SUNDRY NOTICES AND REPORTS ON WELLS

8. Well Name and No.
Cone Federal #159. API Well No.
30-041-2049610. Field and Pool, or Exploratory Area
Tomahawk; San Andres

**Proposed Plugging Procedures
Cano Petro of New Mexico, Inc.
Cone Federal #15
30-041-20496**

**Cone Federal 15
30-041-20496
Tom R. Cone
May 7, 2024
Conditions of Approval**

Cano Petro of New Mexico, Inc.
Cone Federal #15
API 30-041-20496
WBD After PA

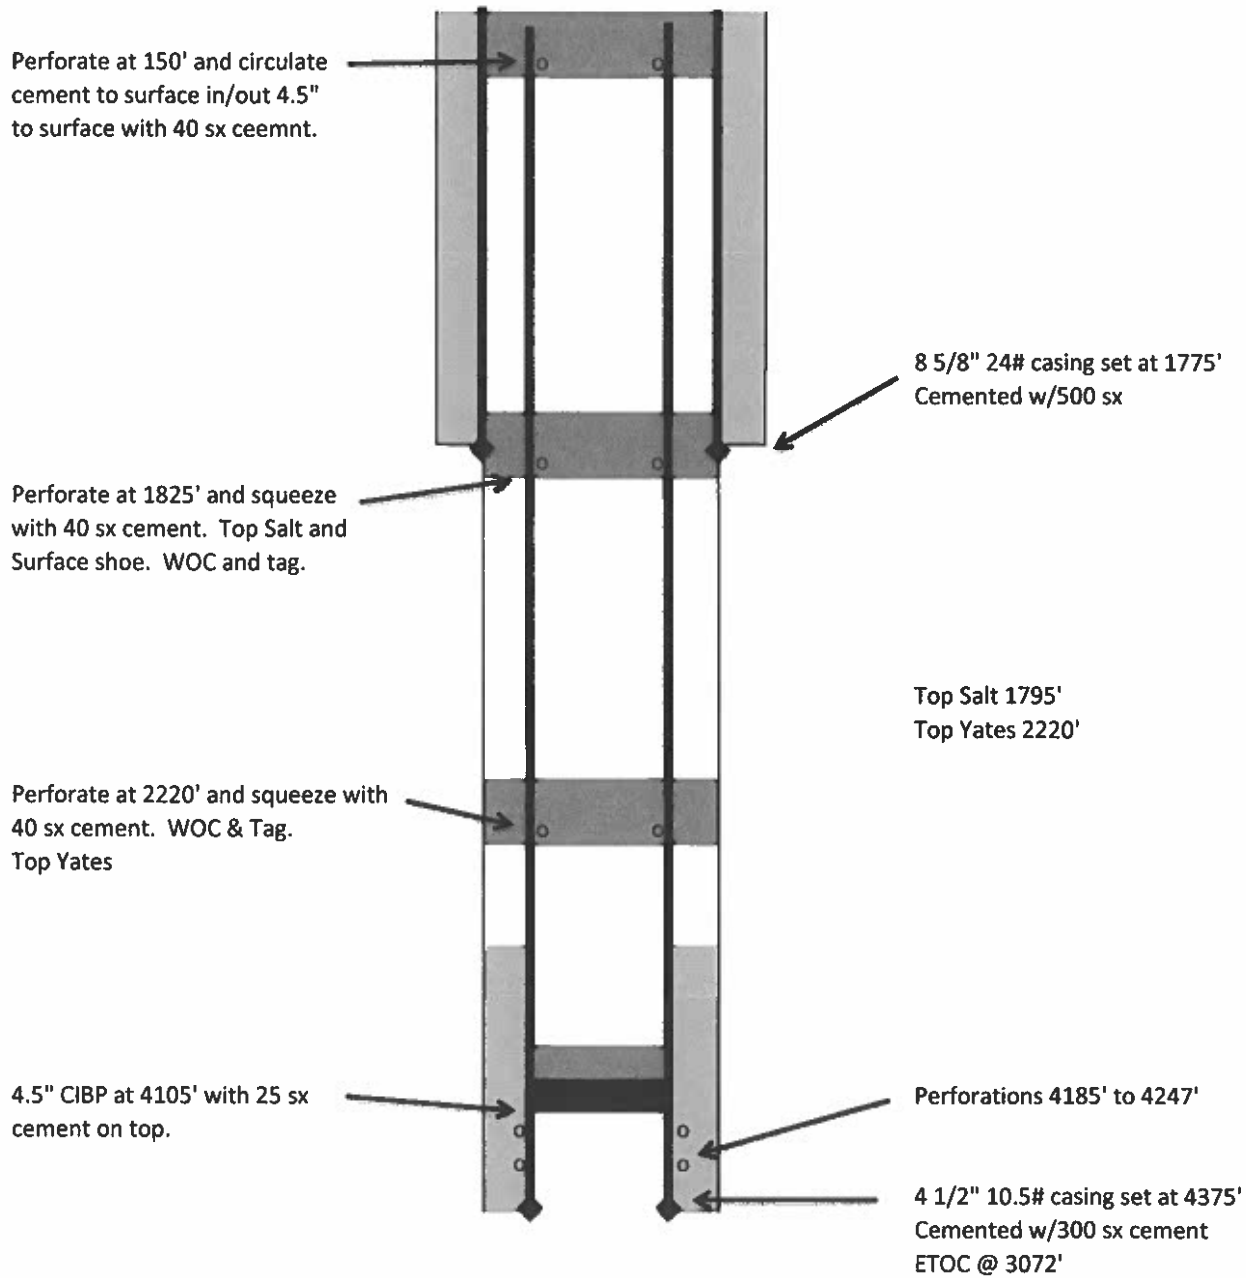
- 1. Operator shall place a CIBP at 4,105' (50'-100' above top perf) and place 25sx of Class C cement on top. WOC and TAG.**
- 2. Operator shall place a balanced Class C Cement plug from 3,120'-2,860' to seal the Queen and Grayburg Formations.**

- 3. Operator shall perf at 2,270' and squeeze cement class C cement to 2,063' to seal the Yates and bottom of Salt. WOC and TAG.**
- 4. Operator shall perf at 1,847' and squeeze cement class C cement to 1,722' to seal the top of Salt, Rustler and 8-5/8" casing shoe. WOC and TAG.**

- 5. Operator shall perf at 150' and squeeze cement class C cement to surface as proposed.**
- 6. Dry hole marker must be below ground.**
- 7. Surface reclamation will need to be completed once the well bore has been plugged. Please contact rflores@blm.gov for additional information.**
